**SUBJECT:** Adoption of the Initial Study / Mitigated Negative Declaration and Mitigation Monitoring and Reporting Plan for the Huff's Corner Levee Raise & Channel Reconfiguration Project

***Responses to Comments & CEQA Mitigation Monitoring and Reporting Program***

Huff's Corner Levee Raise & Channel Reconfiguration Project  
Yolo County, California  
SCH #2021050214

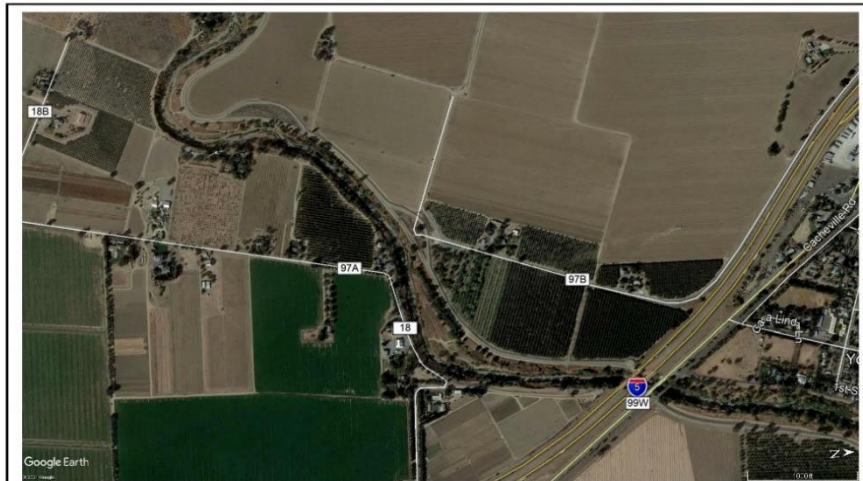
It appears to me that the sedimentation issues that continue to plague the Huff's Corner site are due in large part to the original ACE levee system design for lower Cache Creek, which is evident in the Google Earth imagery in Figure 1. Cache Creek is an entrenched channel in eastern Yolo County, resulting in part from many decades of sediment mining upstream, as well as from altered hydraulic conditions in the Sacramento River floodplain. Entrenchment essentially limits the

In a fluvial geomorphology context, the Huff's Corner location is functionally a sediment trap. The relatively narrow channel cross-section through most of the reach in Figure 1 widens substantially at the Huff's Corner Project location, with the hydraulic effect of reducing the stream power available to maintain inflowing sediment in suspension, particularly coarser sediments in the gravel-to-sand diameter ranges. The consequence is that the Huff's Corner site inevitably accumulates sediment deposits over time. Under the hydraulic properties of the channel/levee system at present, the Huff's Corner site will accumulate sediment until the system reaches an equilibrium in which sediment deposited in the trap is equal to sediment moved out of the trap by the flowing water. Removing sediment currently present in the trap, as proposed by the current project, is a short-term fix, because the hydraulic conditions that support sediment accumulation remain, and the trap will fill with sediment again.

CEQA requires an evaluation of alternatives where there are significant impacts analyzed as part of an Environmental Impact Report. Here, any potentially significant impacts are reduced to less than significant levels through the implementation of mitigation measures identified in the IS/MND. The comment has been noted by staff.

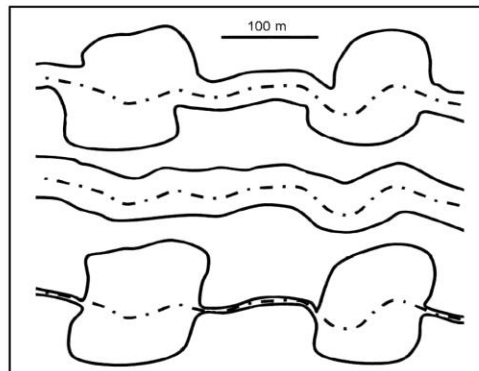
[With respect to riparian habitat elements in the proposed project, it should be noted that the preliminary design includes an ambiguity that could in itself have environmental consequences. The Planting Plan (plan sheet C10) includes a specification to install 'sandbar willow' along the constructed slope of the right bank, above the boulder line. However, the plan sheet identifies the

**Figure 3.1-5**  
**With Proposed Project: Difference in Flood Surface Elevation under the 100-Year Flood Event**

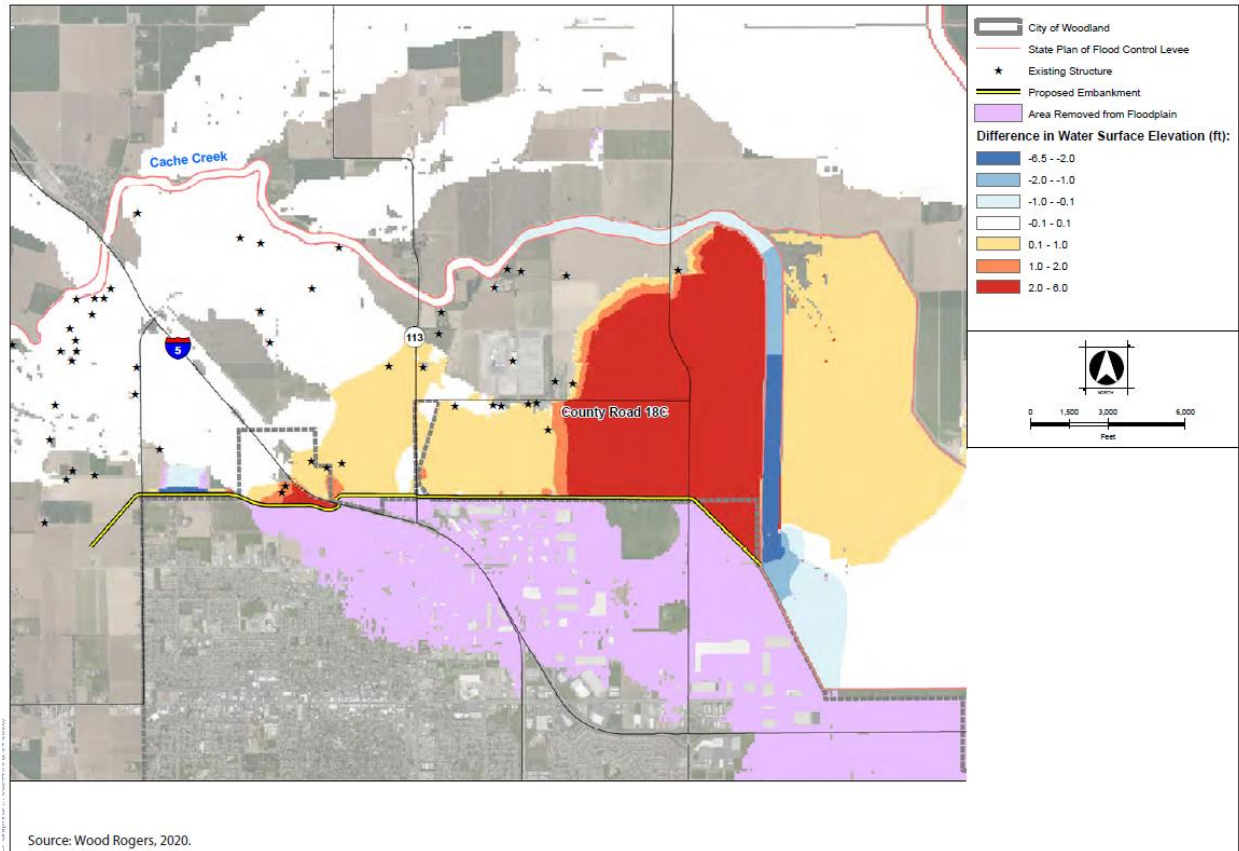
- Currently there is also a proposed project being put forth by the City of Woodland to erect a flood control levee (Flood Wall) to provide 200 year flood protection for the City of Woodland. Has the engineer reviewed what impacts these two projects would have on our properties if both were constructed? If this levee is raised and a flood wall constructed, the waters would overtop behind the homes on County Road 97A (as they do now) and create a flood water bypass for all the properties north of the flood wall, including ours.

The potential for increased inundation was evaluated by comparing with-project and existing conditions within the project area. Figure 3.1-5 shows the differences in water surface elevations with the inclusion of the Proposed Project elements for the 100-year flood. Figure 3.1-6 shows the differences in water surface elevations with the inclusion of the Proposed Project elements for the 200-year flood. As shown in the figures, flooding is no longer present south of the proposed levee (i.e., the city limits), thus meeting the overall project objectives of providing 200-year flood protection and obtaining FEMA certification for the City.

The hydraulic modeling utilized for this analysis assumed that the Huff's Corner levee was at its designed elevation and therefore inherently includes the cumulative impact if both projects are implemented. The location of the commenter is adjacent to Cache Creek in the "white" zone, which shows a difference in water surface elevation with incorporation of the LCCFS Project as -0.1 to +0.1 feet. This does not alter the conclusion for the Huff's Corner project.
